Access Compliance Report

Public Rights-of-Way

Intersection ID: 21826	Main Street: RENFROW_LN	Cross Street: RICHARD_BARRY_DR	Location: NW
ADA ID: 0D7C70DABBE7	Ramp Type: Perp	Initial Pass/Fail: Fail	Overall Compliance: No
		Severity Score: 25

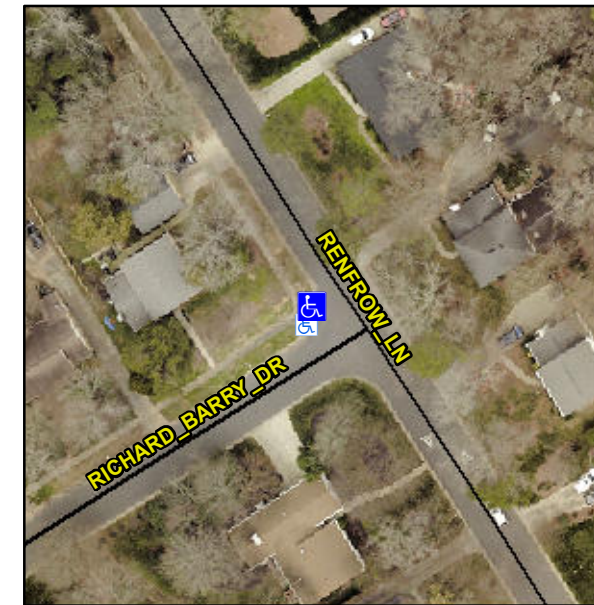
Not Found, R304.2.2, R304.5.3

Compliance	Description	Data	Compliance	Description	Data
N/A	Ramp Length (in)	94.0	No	Ramp Slope (%)	9.3
Yes	Ramp Width (in)	48.0	No	Ramp XSlope (%)	6.8
N/A	Flare Type LT	N/A	N/A	Flare Type RT	N/A
N/A	Flare Slope LT (%)	N/A	N/A	Flare Slope RT (%)	N/A
N/A	Flare Traversable LT?	N/A	N/A	Flare Traversable RT?	N/A
N/A	Landing Length (in)	N/A	N/A	DWS Provided?	N/A
N/A	Landing Width (in)	N/A	N/A	DWS Contrast?	N/A
N/A	Landing Slope (%)	N/A	N/A	DWS Length (in)	N/A
N/A	Landing X Slope (%)	N/A	N/A	DWS Full Width?	N/A
N/A	Landing Curb? (Y/N)	N/A	N/A	DWS Offset (in)	N/A
N/A	Shared Landing?	N/A			
N/A	Gutter Ponding?	N/A	N/A	Gutter Slope (%)	N/A
N/A	Gutter Lip Ht (in)	N/A	N/A	Gutter X Slope (%)	N/A
N/A	Painted X Walk1?	No	N/A	Painted X Walk2?	N/A
	X Walk 1 Direction	To E		X Walk 2 Direction	N/A
N/A	X Walk 1 Width (in)	N/A	N/A	X Walk 2 Width (in)	N/A
	X Walk 1 Slope (%)	9.2		X Walk 2 Slope (%)	N/A
	X Walk 1 X Slope (%)	5.6		X Walk 2 X Slope (%)	N/A

Remove & Replace Entire Ramp.
